# CITY COUNCIL MEETING

# City of Davenport, Iowa

To: Matt Flynn Community Planning and Economic Development

Re: Proposed Costco Site Plan Review

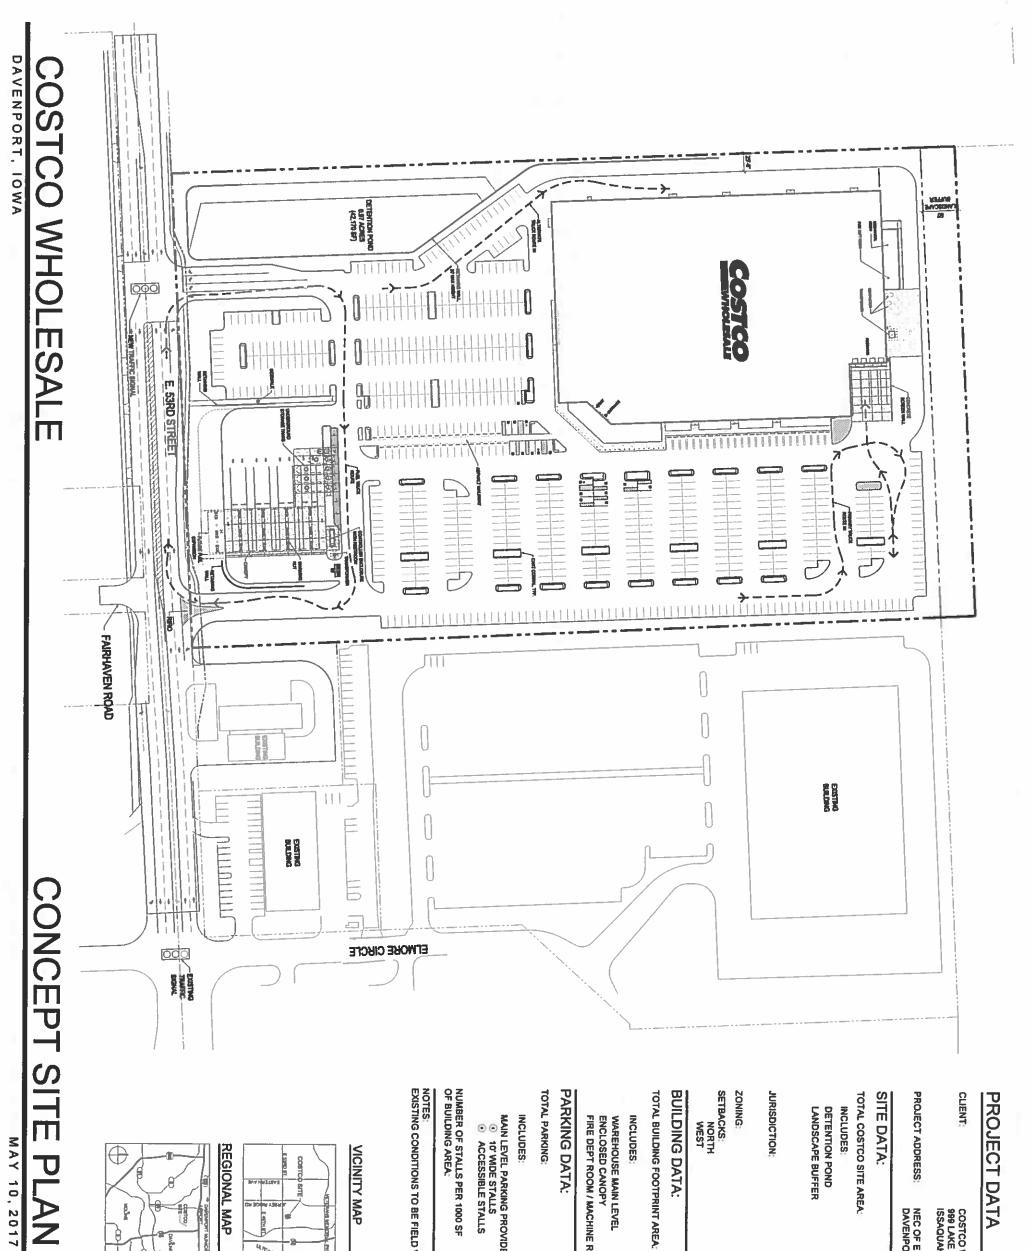
Prior to the approval of the above referenced plat the following conditions need to be addressed:

- 1. The new right of way line and sidewalk should both be shown as straight lines between the two driveways rather than offsetting to the south. Although this may interfere with the future fuel expansion, it appears that a setback variance may be needed in any case.

- 4. Along with the delivery truck entrance path the exit path should also be shown on the plan. Trucks should be able to exit to the east.
- 5. Drainage patterns need to be reviewed, especially on entrances. Water runoff cannot increase on residential property to the south

likely already have conduit and fiber optic cable along this corridor when the signals are installed. City staff will create the timing plan for the signals.
